Title:	MCC HVAC Upgrades			
Number:	SB_588.3	Release Date:	6/20/2022	
Revision Number:	3	Revision Date:	1/5/2023	
Chassis Type:	Velocity, Impel, Enforcer			
Component Description:	MCC HVAC SYSTEM			
Warranty:	N/A			
Parts:	N/A			
Tools:	N/A

Addressing fault codes and upgrades to the MCC HVAC system.

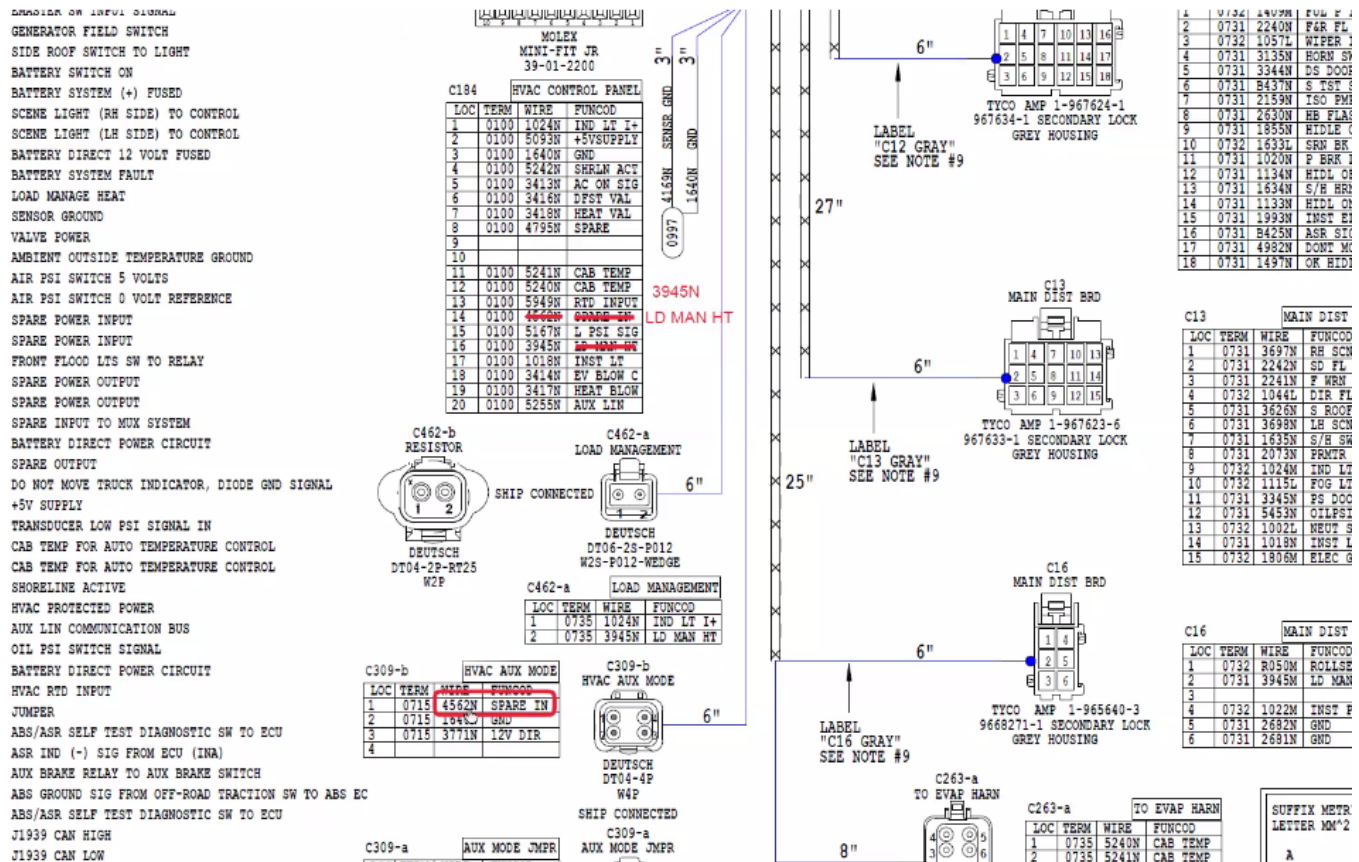
If it is determined that the control panel requires the updated software, please start a Technical Incident and you will be advised what below option is best suited for the vehicle.

1. Control panel part number # **63-4753-0002**.
 - a. This panel is the current, production version from HED with 7.10 software installed
2. Control panel part number # **4231502**.

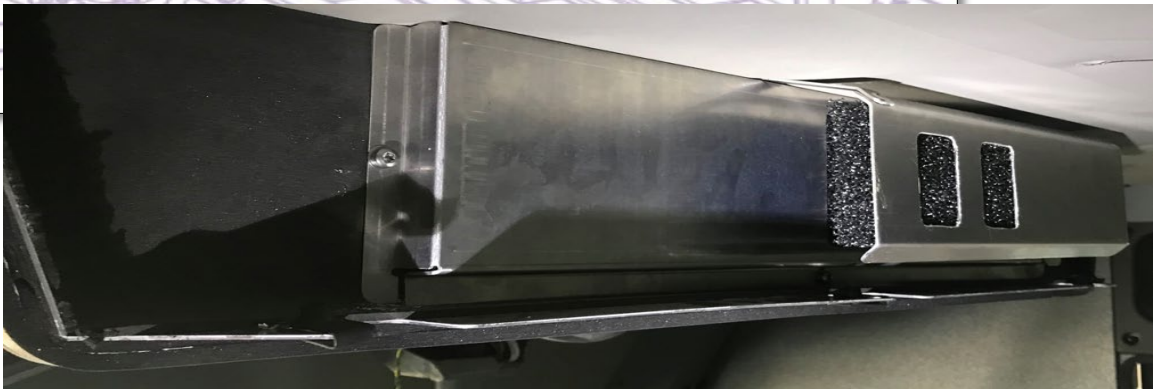
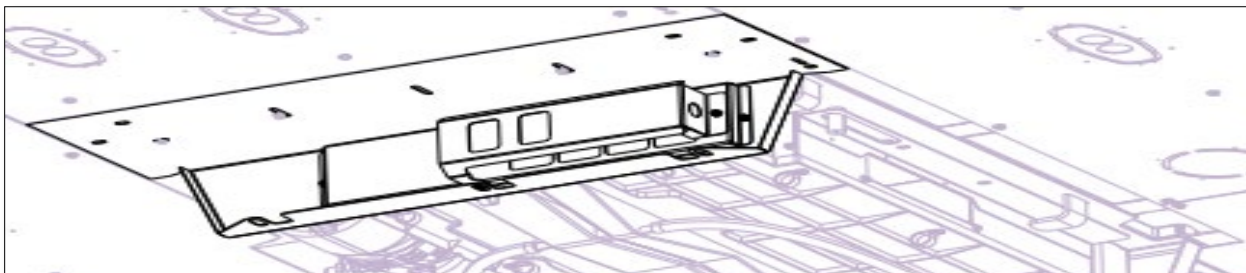
4. If vehicle is hardwired (not using multiplex networking) re-pin load manager connector to control panel part number # **63-4753-0002**.

- a. With the correct Mini-Fit Junior pinning tool, re-pin wire 3495 in connector C184 from pin 16 to pin 14.
- b. If the correct Mini-Fit Junior pinning tool is not available:
 - i. Cut wire 3495 at connector C184.
 - ii. Connect wire 3495 to wire 4562 at connector C309.
 - iii. Leave wire 4562 in connector C184 pin 14.
- c. Refer to diagram below.
